Reasons for Decision

Conditional Approval of 2019 Final Closure Plan for Cobble Hill Holdings Landfill

**Re: Leachate Generation Review – Task 4
Review of the Cobble Hill Landfill Updated Final Closure Plan 2019
460 Stebbings Road Near Shawnigan Lake, British Columbia**

RE: Review of Groundwater Information in the Cobble Hill Landfill Closure Plan

Figure 3. Water levels in the monitoring wells shown taken from the Quarter 3, 2016 Report by the Named Parties.

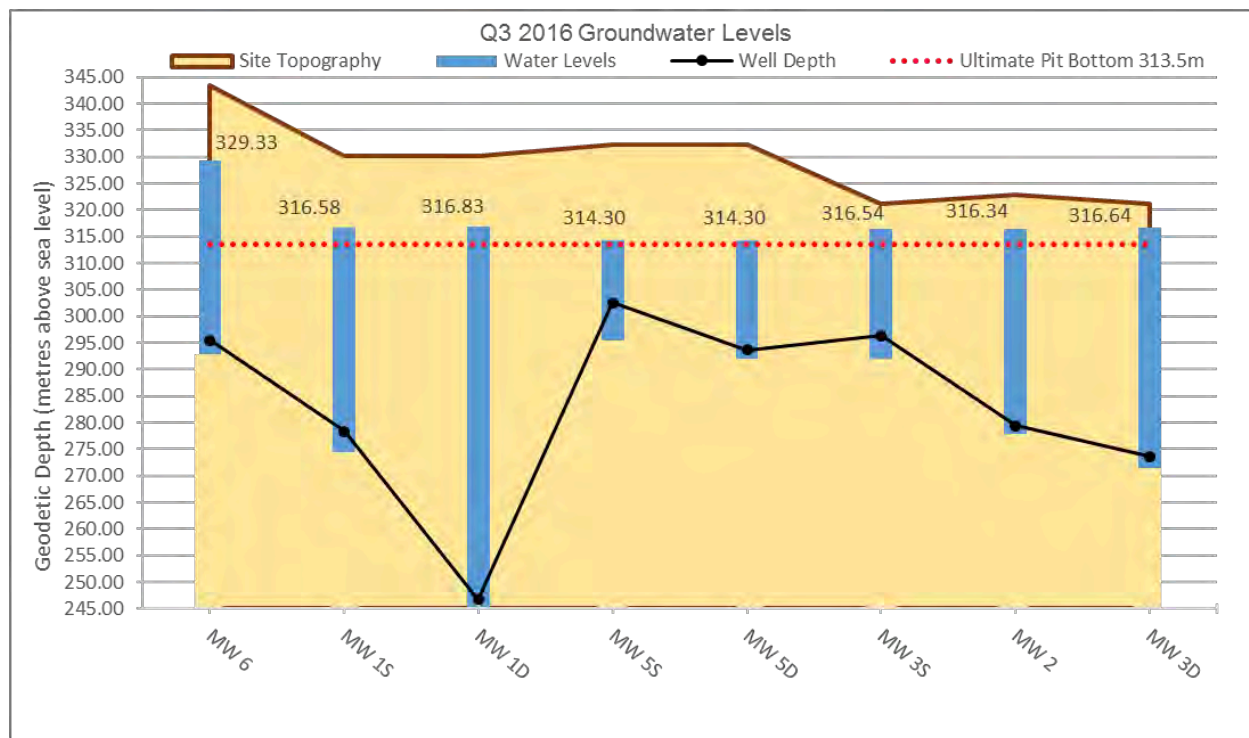
The Ministry previously informed the SRG that its hydrogeologist stated that the high ionic content of Monitoring Well #6 is due to the fact that this is a much deeper well than all the other monitoring wells. This clearly is incorrect as can be seen in Figure 3.

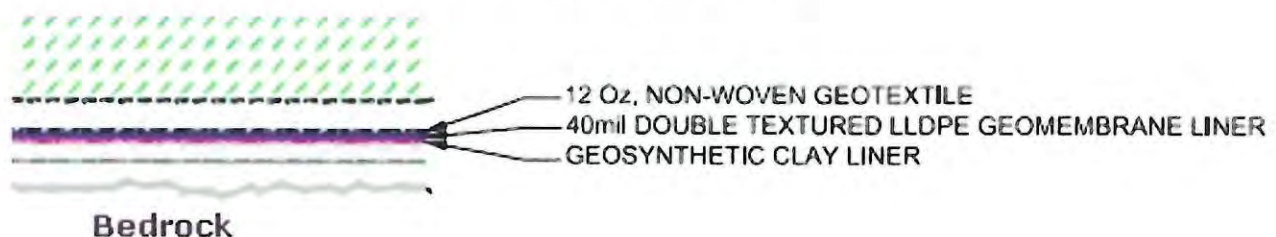
The **As Built** seepage layer does not provide an adequate base for the clay liner. It certainly does not meet the **16Spec**.
